Access Compliance Report

Public Rights-of-Way

Intersection ID: N/A	Main Street: AGNEW_DR	Cross Street: SOLAR_WY	Location: NE
ADA ID: B17CD858715F	Ramp Type: BlendTrans1	Initial Pass/Fail: Fail	Overall Compliance: No
		Severity Score: 33.75

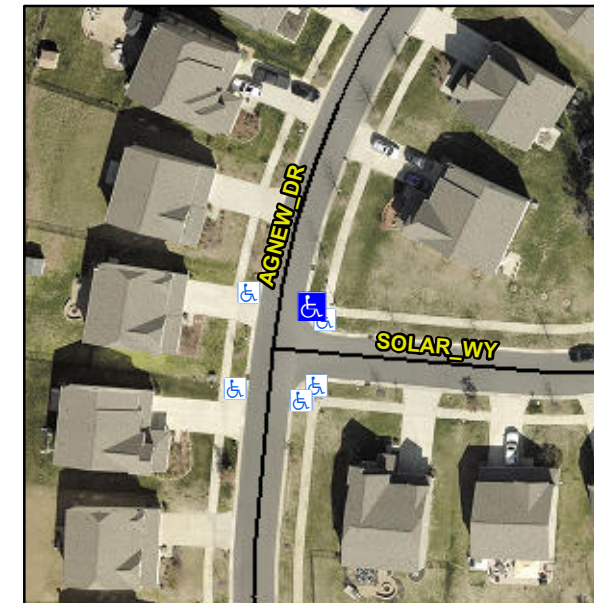
Not Found, R304.5.1, R304.5.3

Compliance	Description	Data	Compliance	Description	Data
N/A	Ramp Length (in)	98.0	Yes	BlendTrans Slope (%)	4.2
No	Ramp Width (in)	39.0	No	BlendTrans XSlope (%)	8.5
N/A	Flare Type LT	N/A	N/A	Flare Type RT	N/A
N/A	Flare Slope LT (%)	N/A	N/A	Flare Slope RT (%)	N/A
N/A	Flare Traversable LT?	N/A	N/A	Flare Traversable RT?	N/A
N/A	Landing Length (in)	N/A	N/A	DWS Provided?	N/A
N/A	Landing Width (in)	N/A	N/A	DWS Contrast?	N/A
N/A	Landing Slope (%)	N/A	N/A	DWS Length (in)	N/A
N/A	Landing X Slope (%)	N/A	N/A	DWS Full Width?	N/A
N/A	Landing Curb? (Y/N)	N/A	N/A	DWS Offset (in)	N/A
N/A	Shared Landing?	N/A			
N/A	Gutter Ponding?	N/A	N/A	Gutter Slope (%)	N/A
N/A	Gutter Lip Ht (in)	N/A	N/A	Gutter X Slope (%)	N/A
N/A	Painted X Walk1?	No	N/A	Painted X Walk2?	N/A
	X Walk 1 Direction	To W		X Walk 2 Direction	N/A
	X Walk 1 Width (in)	N/A		X Walk 2 Width (in)	N/A
	X Walk 1 Slope (%)	2.5		X Walk 2 Slope (%)	N/A
	X Walk 1 X Slope (%)	4.5		X Walk 2 X Slope (%)	N/A

Remove & Replace Curb Ramp With Two New Directional Ramps or Equivalent.
